22 June 2012

**RENOVATIONS & ADDITIONS  
NORTHWEST HIGH SCHOOL  
CLARKSVILLE, TN**

**ADDENDUM NO. TWO**

**CONTRACTOR'S OPTION**  
**L1,L4,L8 DETAIL - PARAPET**  
**A122**

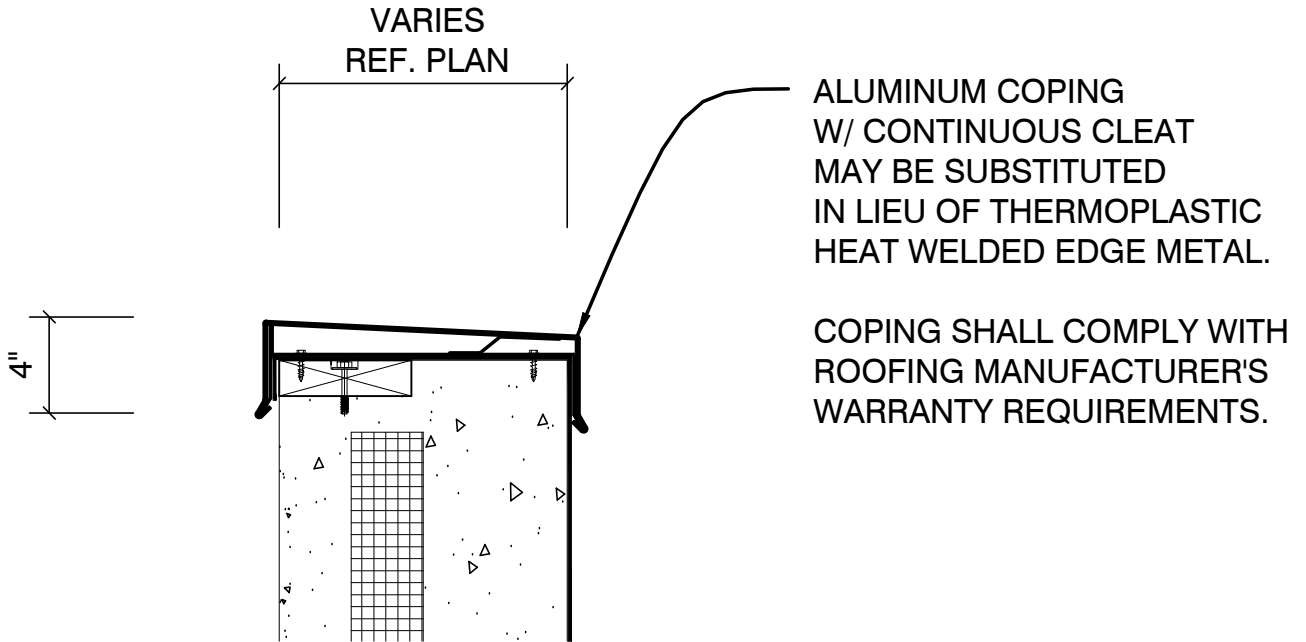
- ITEM 43.  
SHEET A122 – DETAILS – ROOFING, L1, L4, & L8 DETAIL – PARAPET; Add the following Contractor’s Option on supplemental Drawing L1, L4, & L8 /A122 attached hereto.

**P18**  
**A121**

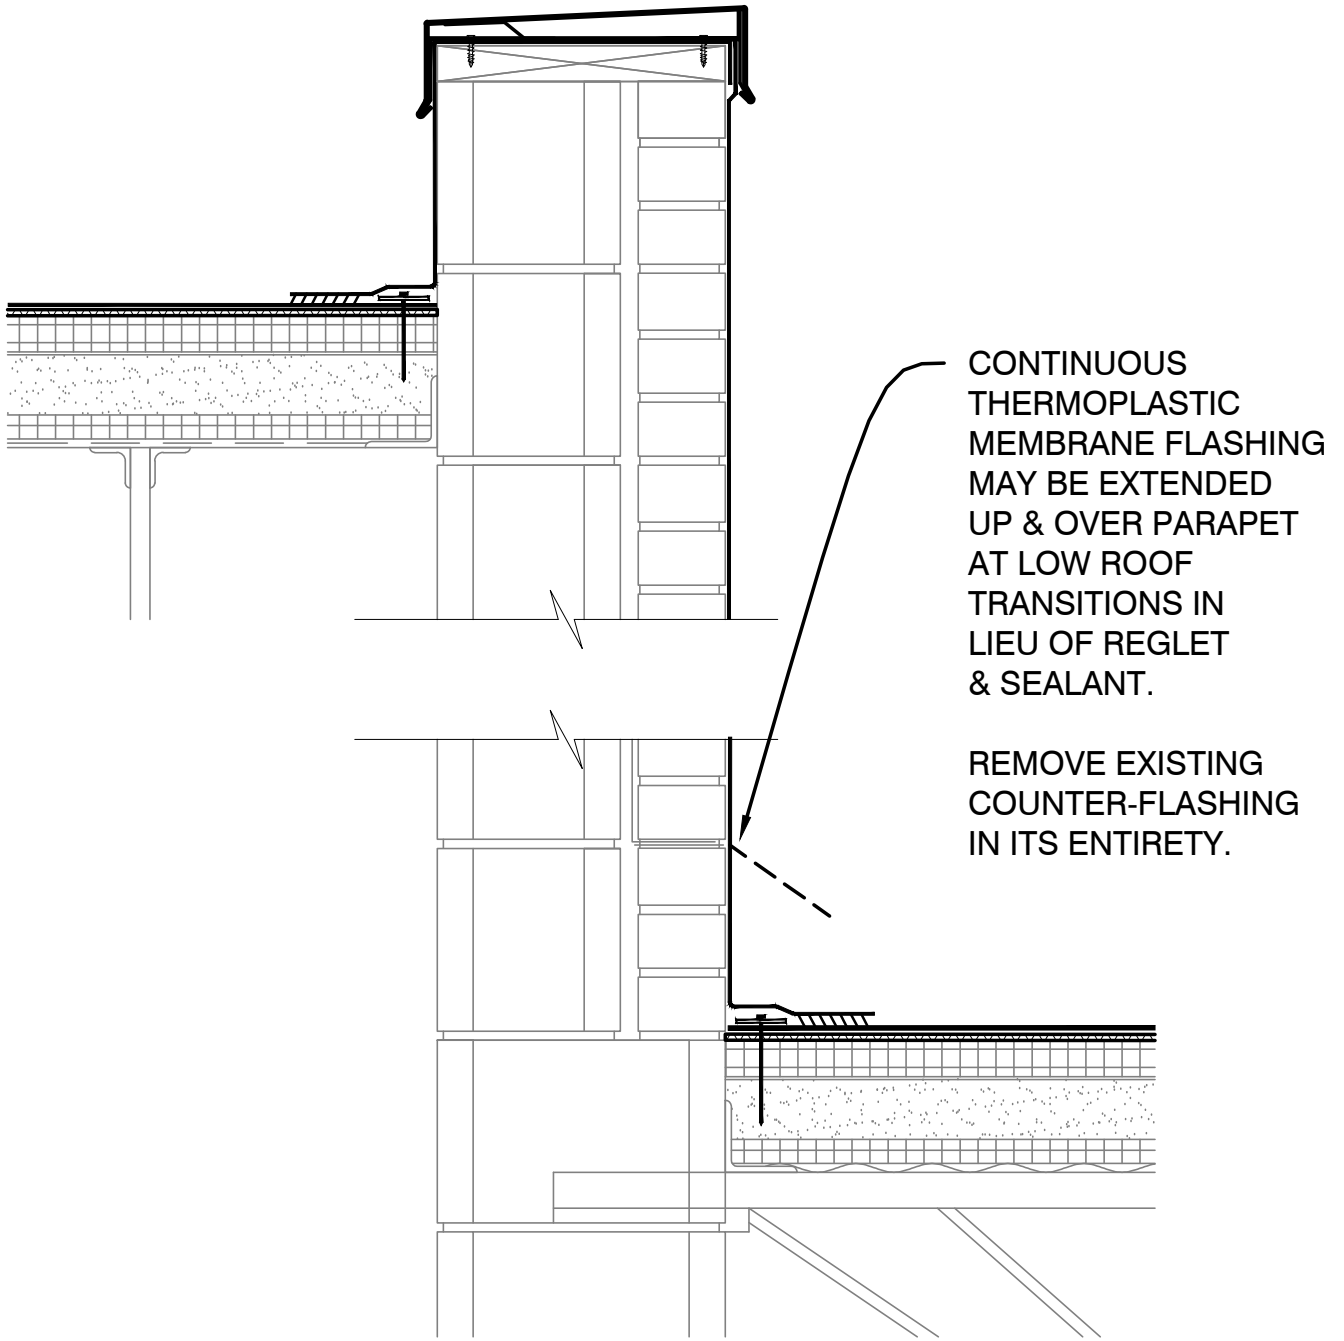
- ITEM 42.  
SHEET A121 – DETAILS – ROOFING, P18 DETAIL – PARAPET; Add the following Contractor’s Option on supplemental Drawing P18/A121 attached hereto.

**G1**  
**A122**

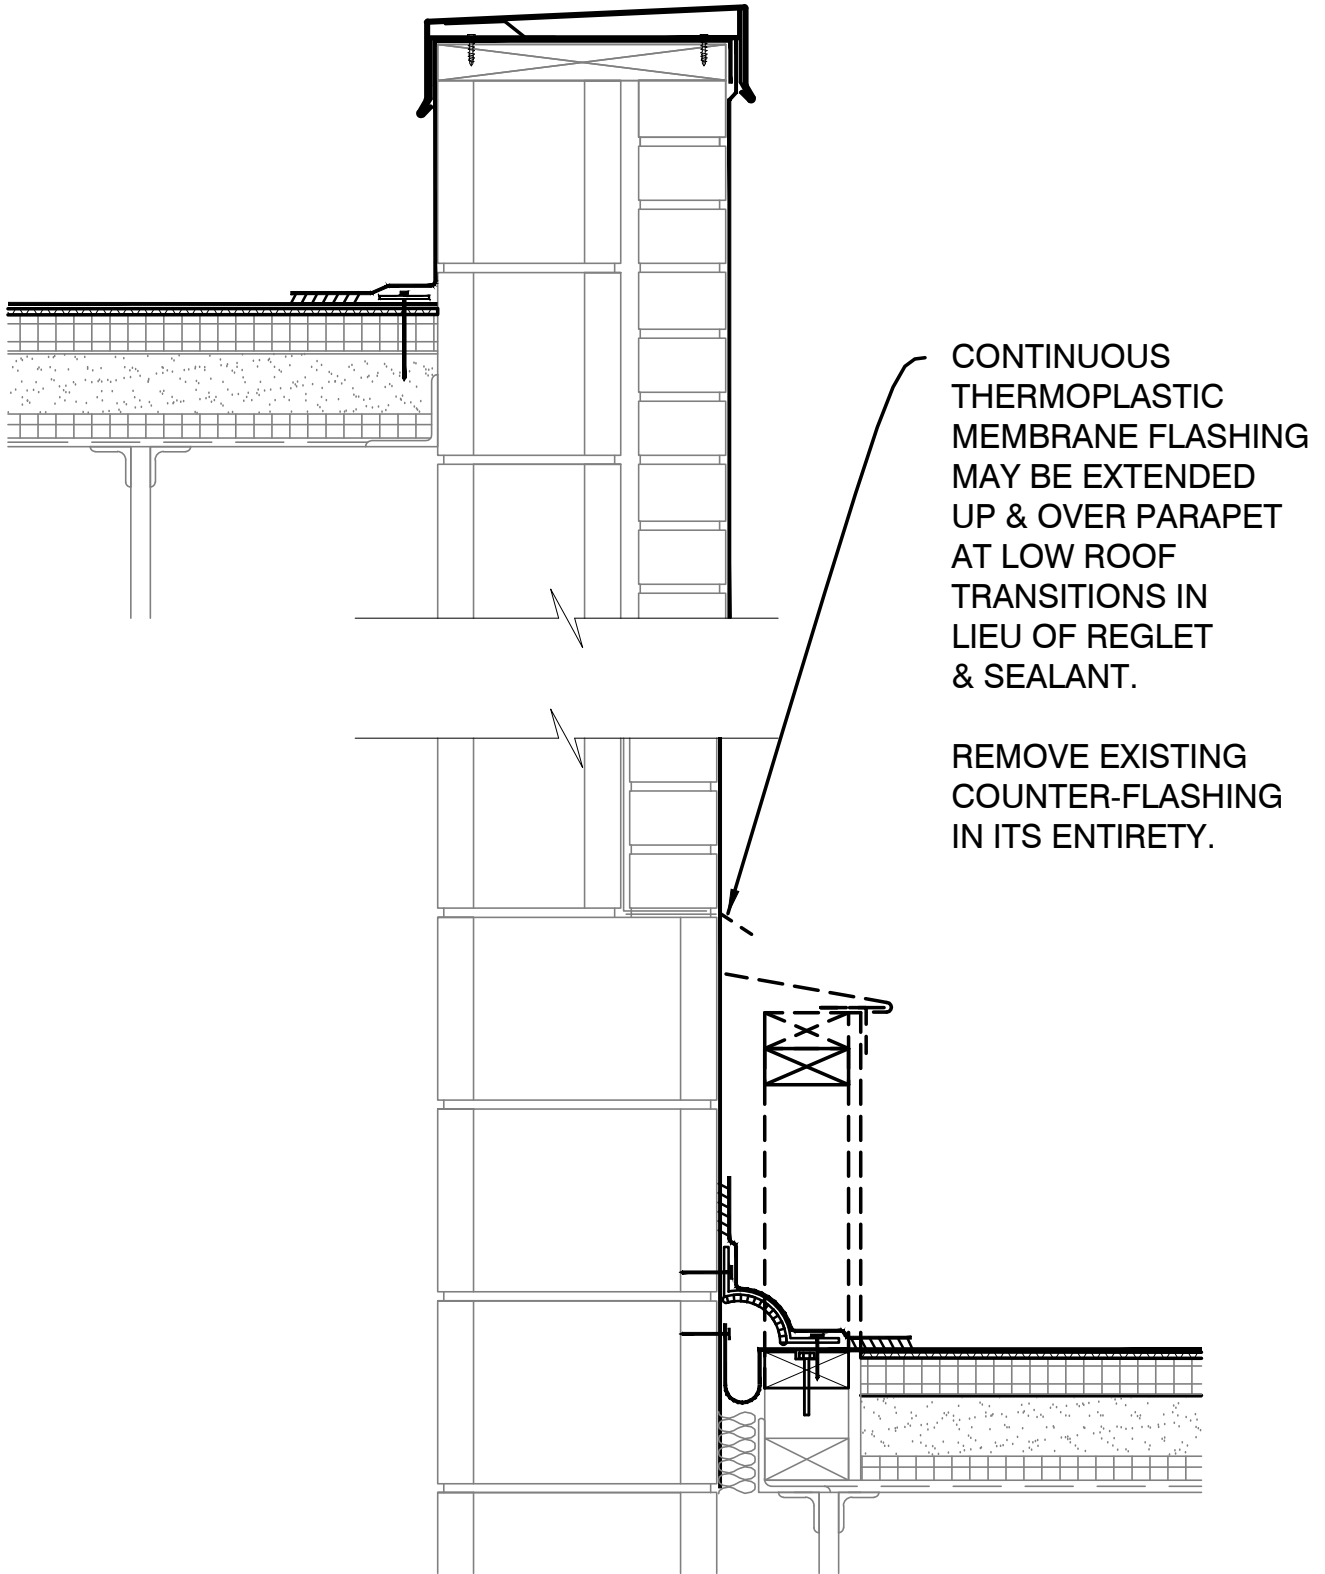
- ITEM 44.  
SHEET A122 – DETAILS – ROOFING, G1 DETAIL – WALL FLASHING; Add the following Contractor’s Option on supplemental Drawing G1 /A122 attached hereto.

P8  
A122

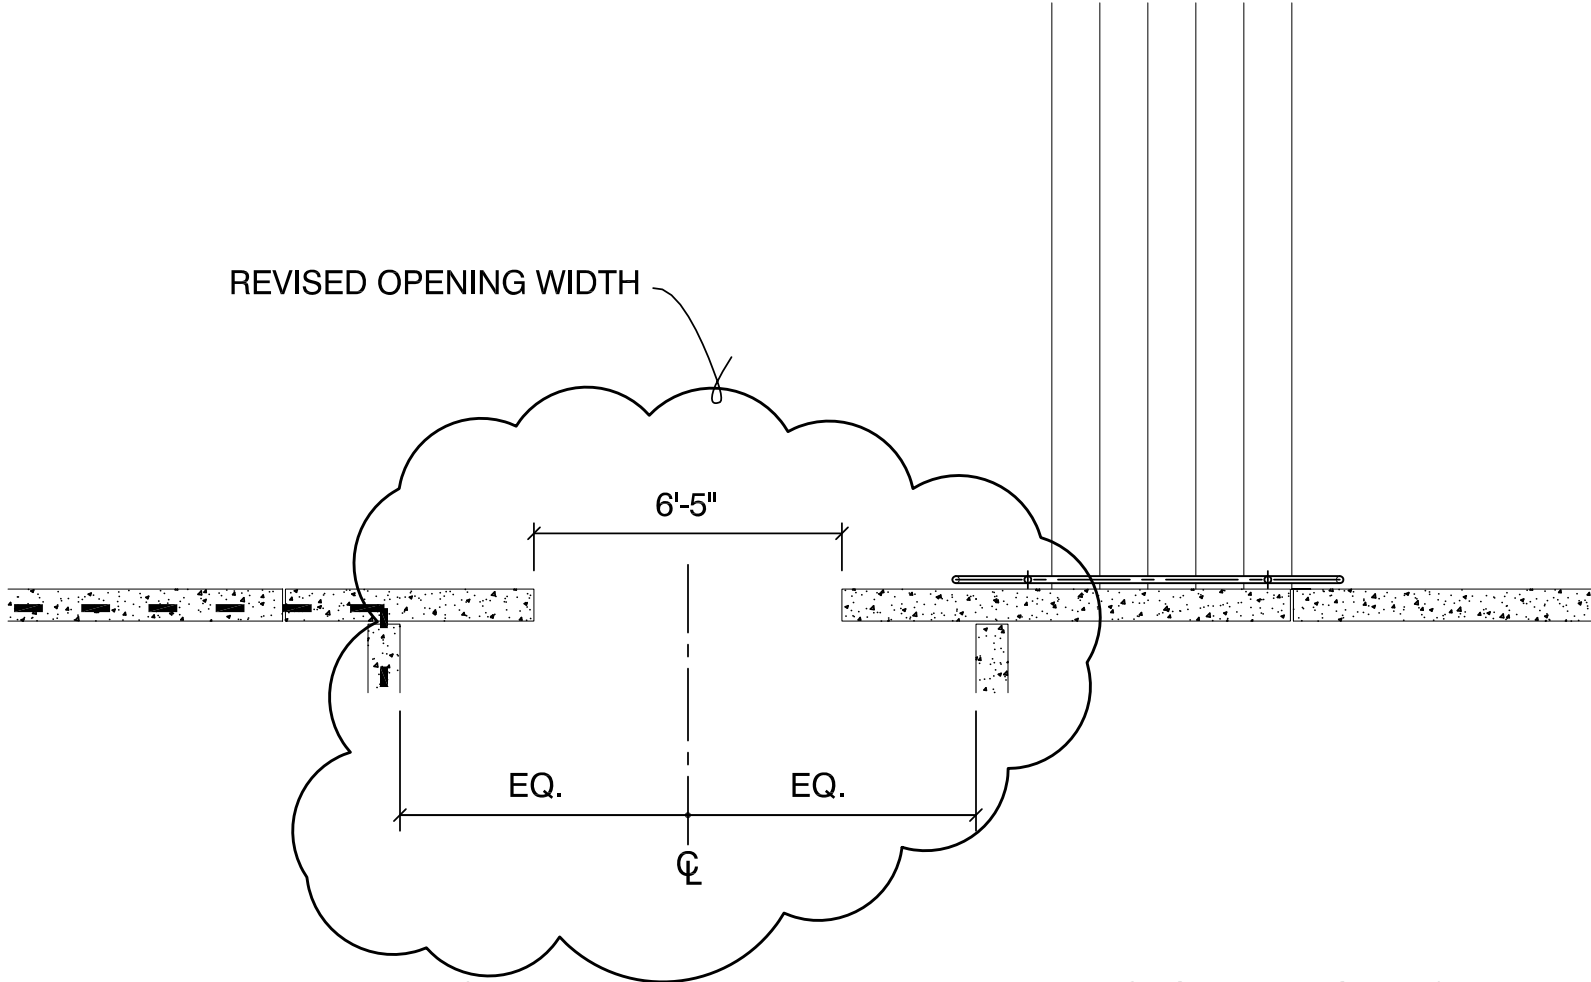
- ITEM 45.  
SHEET A122 – DETAILS – ROOFING, P8 DETAIL – EXPANSION JOINT; Add the following Contractor’s Option on supplemental Drawing P8 /A122 attached hereto.

J5  
A304

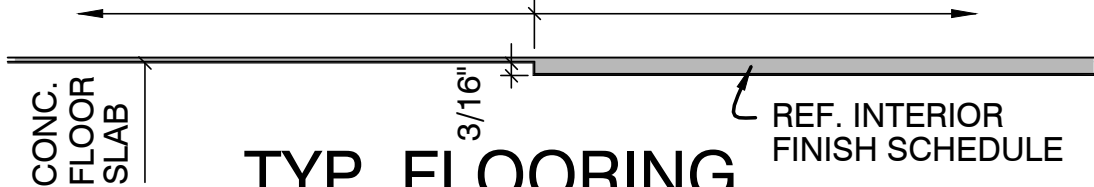
- ITEM 48.  
SHEET A304 – STAIRS RAMPS GUARDS & RAILINGS, J5 ENLARGED PARTIAL PLAN - COMMONS 033; Add J5/a304 attached hereto. CLARIFICATION: Provide 6'-5" opening width as shown on revised Drawing.

REVISED OPENING WIDTH

# TYP. FLOORING TYPE TRANSITION

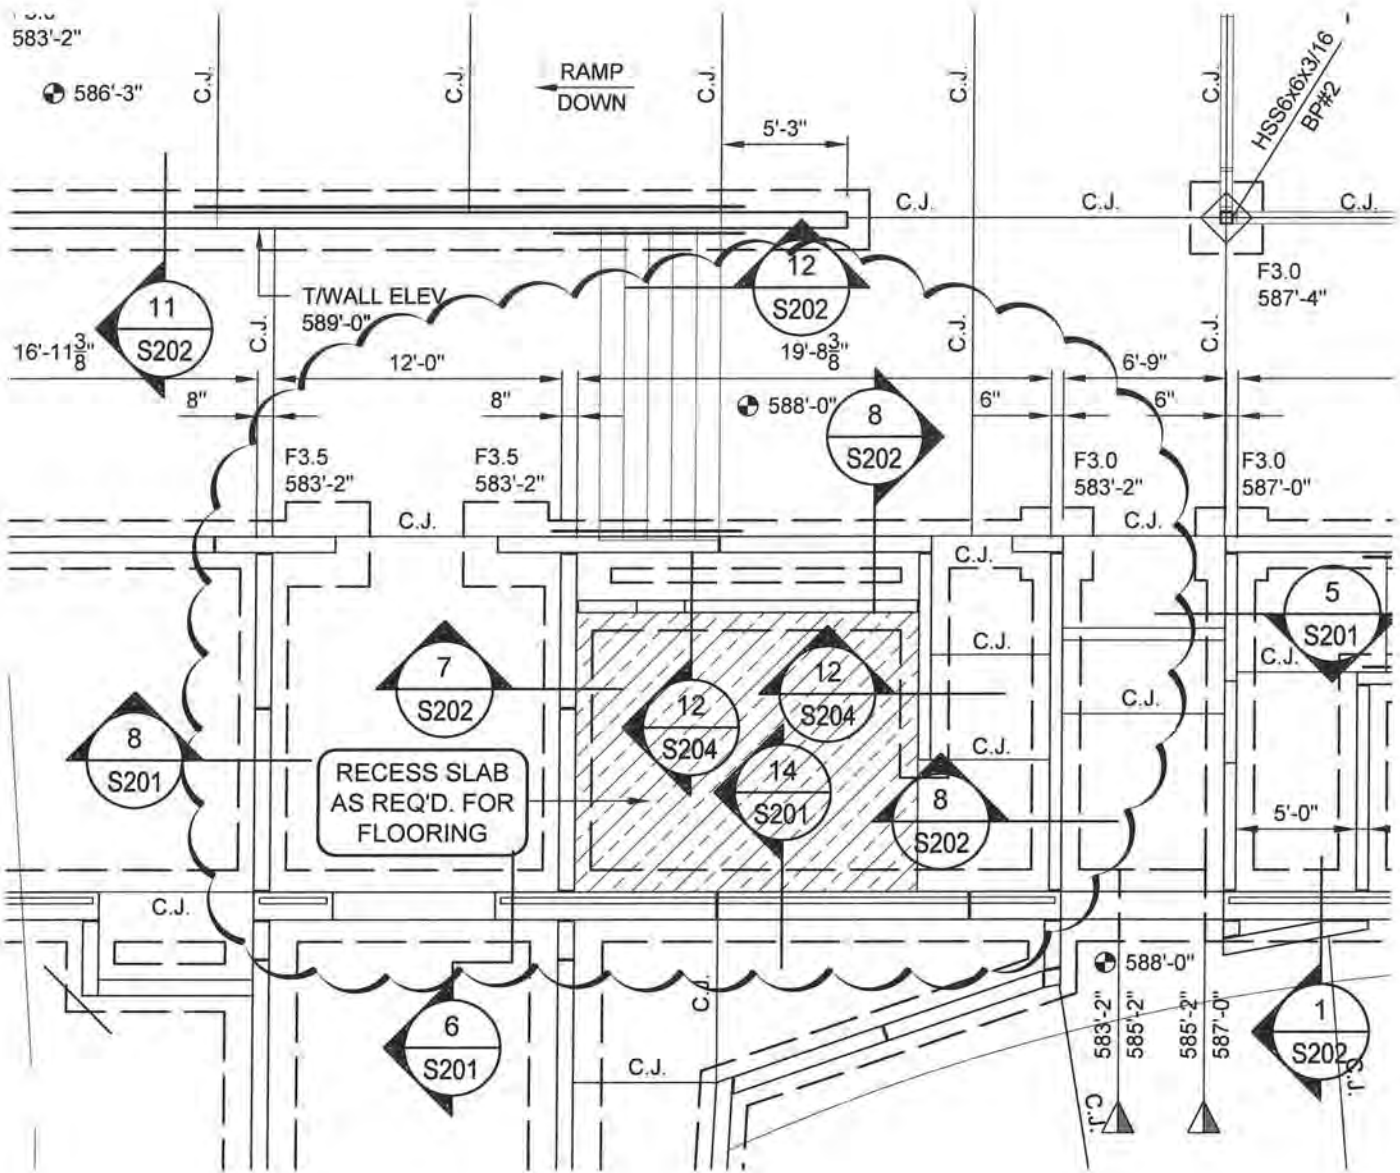
- ITEM 49.  
SHEET ID03 – CEILING-MEZZANINE RENOVATION; Add DETAIL N9 – TYP. FLOORING TYPE TRANSITION attached hereto.
- ITEM 50.  
SHEET ID11 – INTERIOR FINISH SCHEDULE; GENERAL NOTES Add the following: “REFER TO BUILDING SECTIONS FOR EXTENT OF PRECAST ARCHITECTURAL CONCRETE HORIZONTAL RUSTICATION EXPOSED ON INTERIOR.”

**FOUNDATION PLAN - MEDIA CENTER REN.**

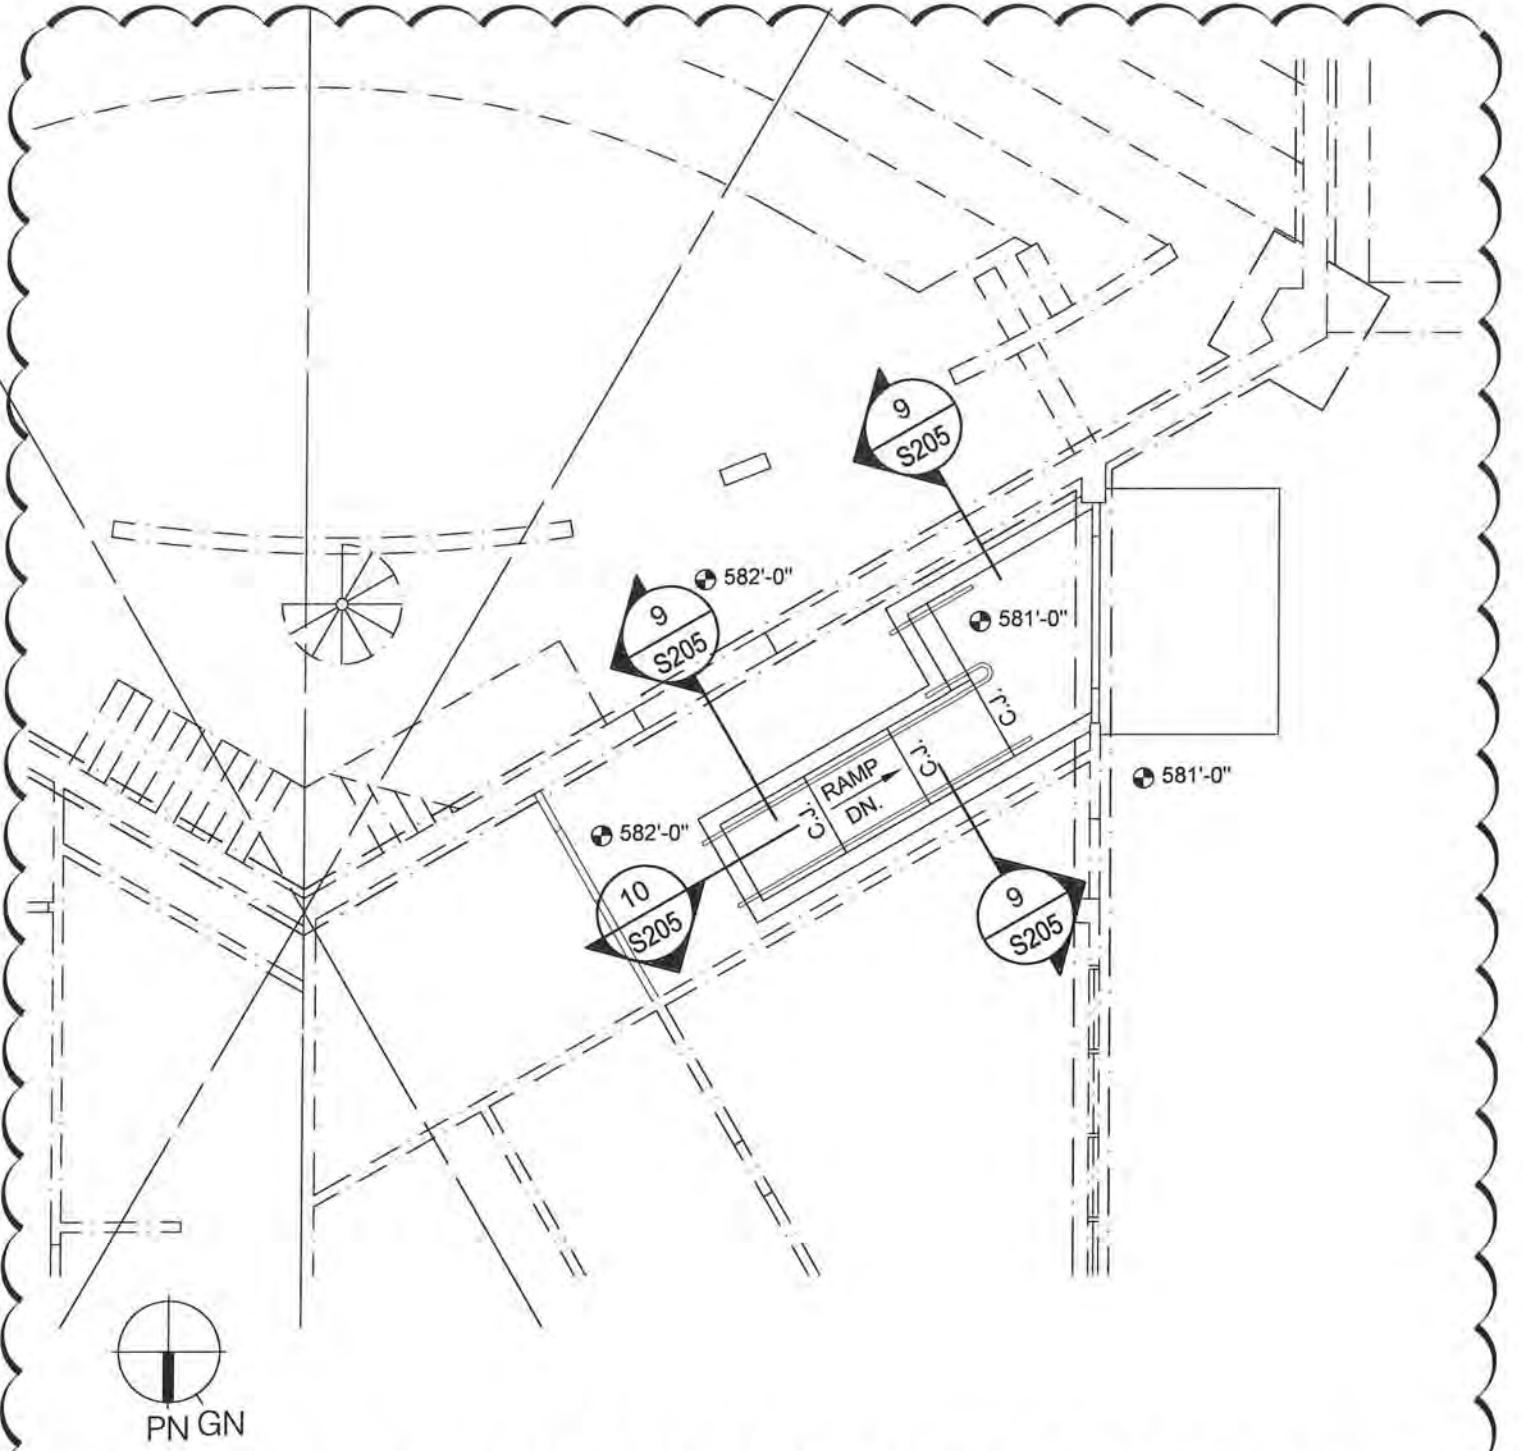
SHEET S105 – CANOPY ADDITIONS & MEDIA CENTER REN.; Provide ramp at Media Center Renovation. Add Supplemental Plan S105a attached hereto.
